COUNCIL SUBMISSION TO MODIFIED STATE SIGNIFICANT DEVELOPMENT APPLICATION - SYDNEY OLYMPIC PARK HIGH SCHOOL (7 Burroway Road, Wentworth Point)

CITY OF PARRAMATTA COUNCIL SUBMISSION – PROPOSED SYDNEY OLYMPIC PARK HIGH SCHOOL - 7 BURROWAY ROAD, WENTWORTH POINT

Figure 1: Amended SSD changes

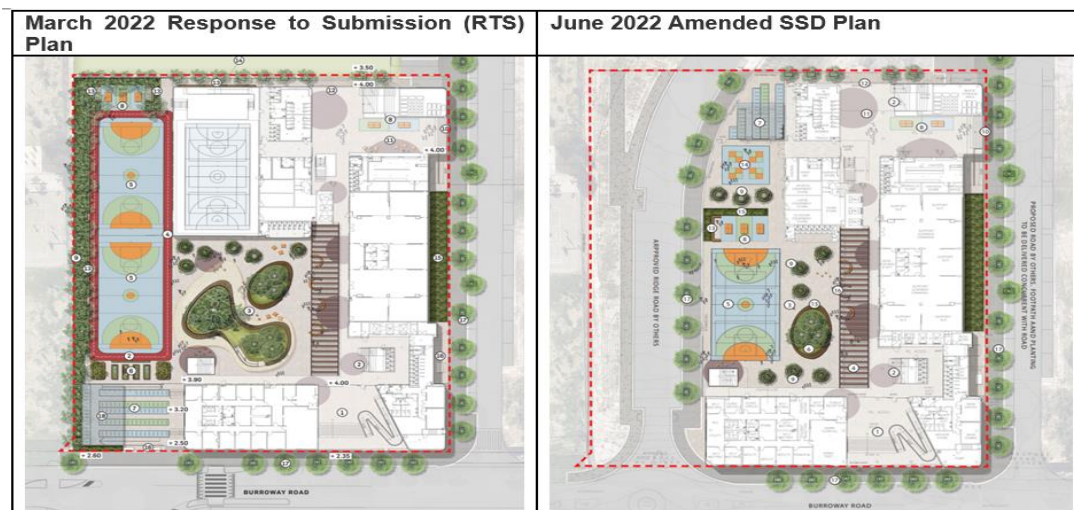
The changes made in this most recent modified SSD compared to the last modified SSD provided in March are shown in **Figure 1** below.
